Subject: Remora (MacArthur) bus stop for comment

From: Chris Mancini <Chris.Mancini@brisbane.qld.gov.au>
Sent: Wednesday, 19 April 2017 12:37 PM
To: Corey Baldwin
Cc: Jaimee Boutcher-Hann
Subject: RE: Macarthur Ave Bus Stops

Subject: Northshore Hamilton - Remora MacArthur Upgrade signals drawings

TITLE: PROJECT WIDE CONDUITS LAYOUT PLAN SHEET 16

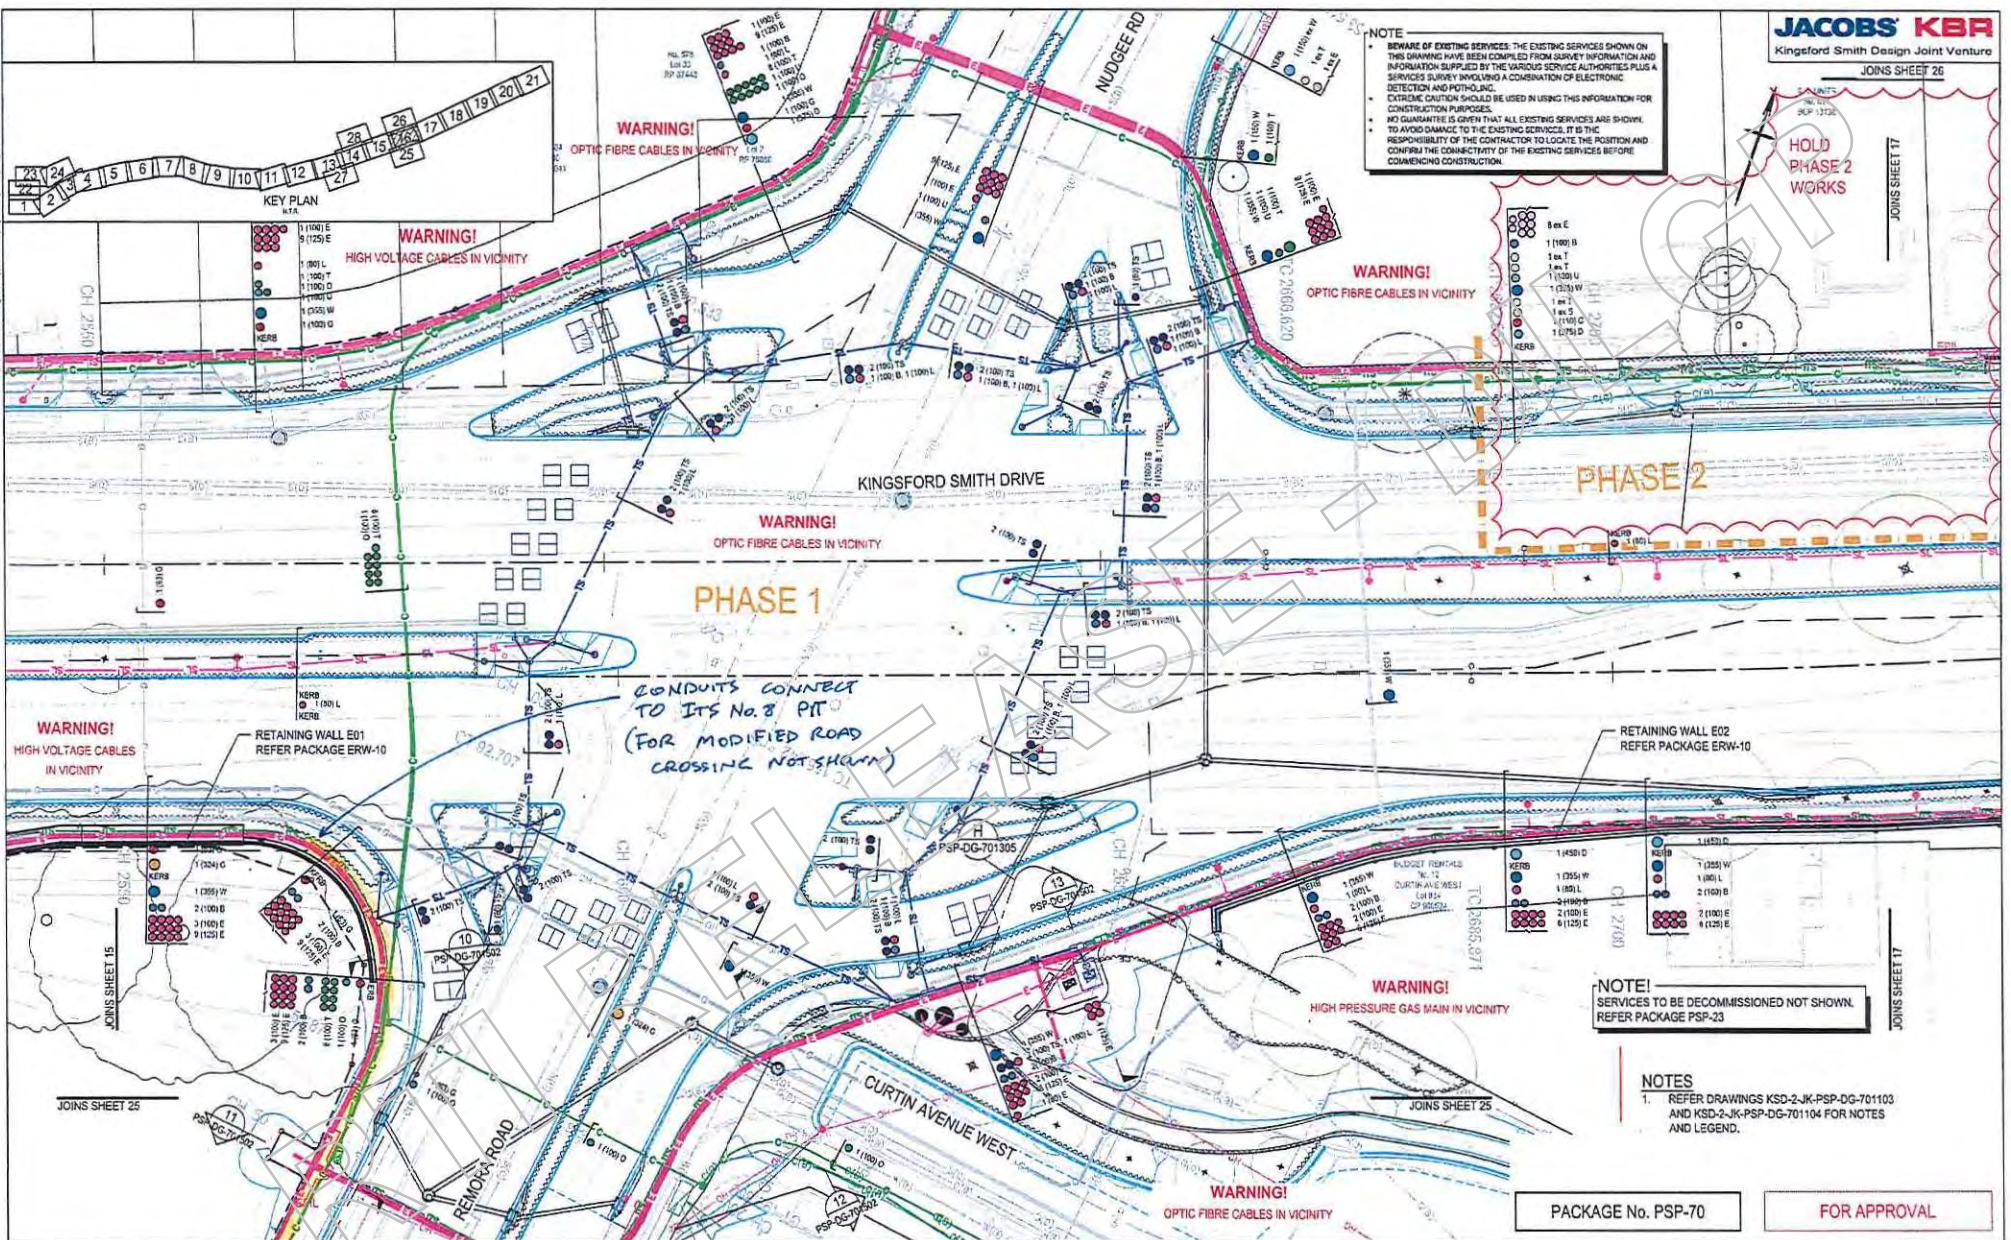
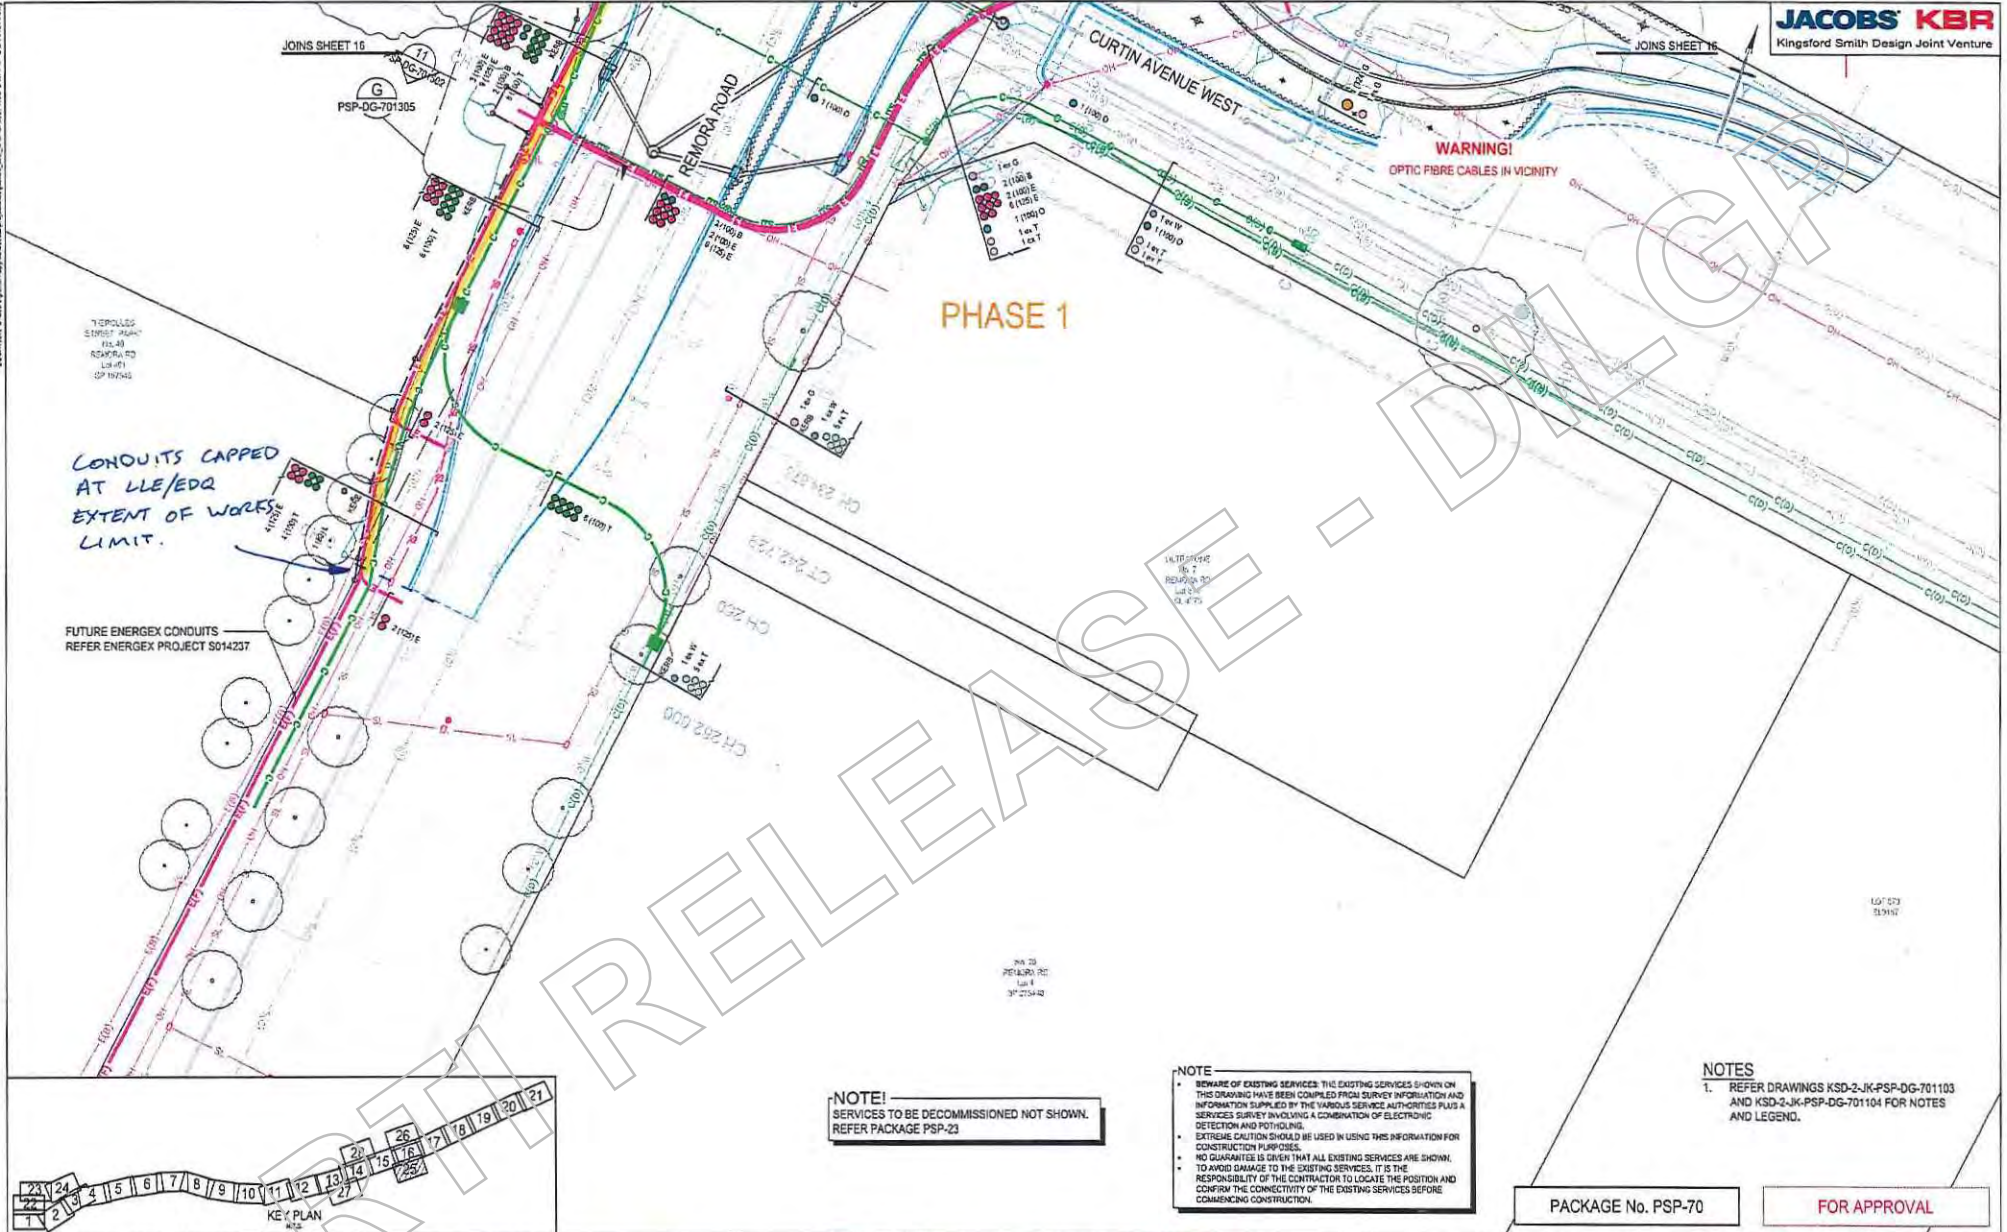
- KSD project will install spare BCC-ITS conduits from south west corner of Remora/KSD down to KSD Upgrade/EDQ interface - refer to attached plan.
- Attached is the KSD Fibre information from our Comms team. Advising EDQ to use cores 43/44 for BXXX1 and 45/46 for BXXX2 of Remora C067_J1 on cable FO1563/48 TO Hunt St Mux.
- Fibre specification will be sent later today.
- Would then propose EDQ Contractor to liaise with Council for their required fibre design and their connection to KSD fibre network (using the new conduits at KSD and LLE fibre design PIT-10)
- Once fibre network is in place, or to a sufficient status, EDQ Contractor can then connect to.

But, we would like to request Project to show this conduits on a separate set of plans, and also provide a telecommunications/fibre plan for Councils future referencing.

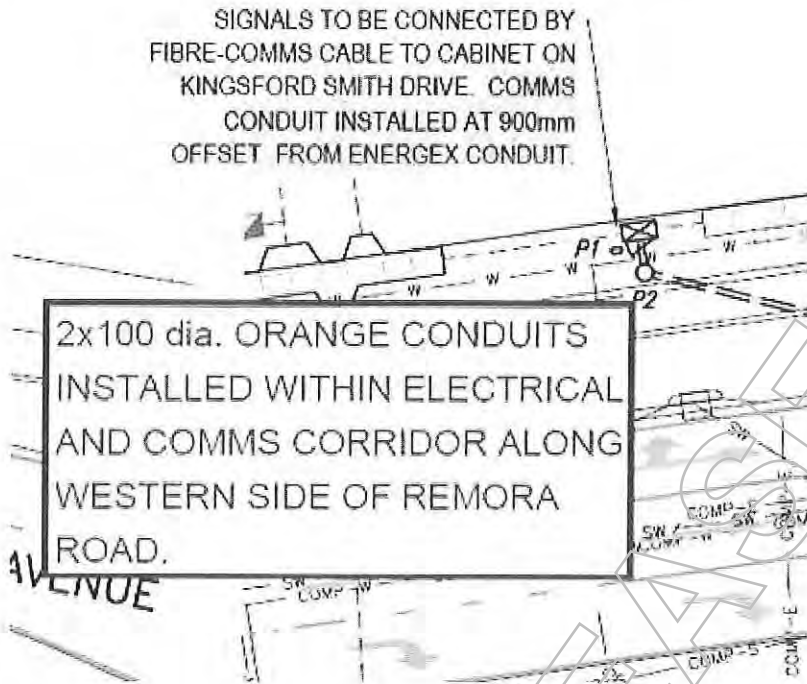
Further to our meeting on Friday regarding the BCC Comms conduits and as requested please find attached a copy of our signals drawings for comment/acceptance.

In regards to the notes for connection, these will be installed as per our discussions last week. The text highlighted yellow below should be changed to something more like the text in red. For the Finnegan Street (this street name will be corrected on the plans) signals the corridor will be on the south side of MacArthur Avenue.

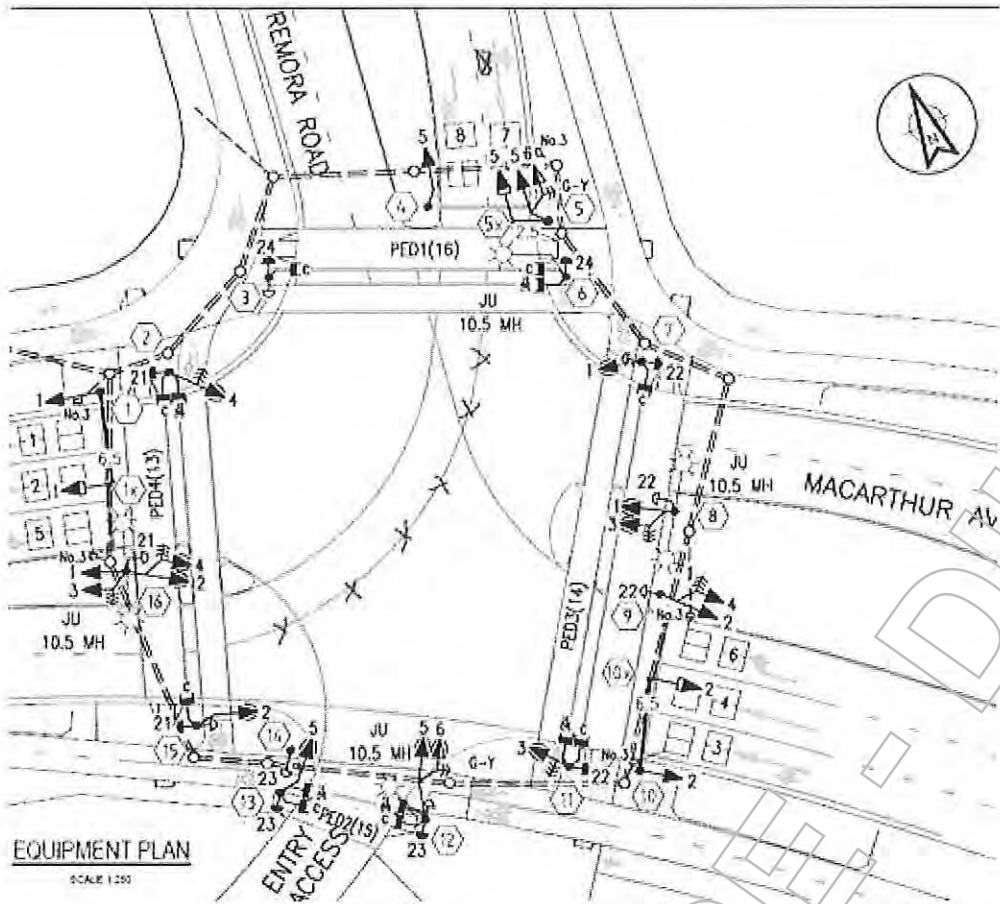
Another minor change which we are looking to adopt which will not affect signal phasing is to remove the right turn movement from the left southbound lane on Remora Road as per the below mark up.
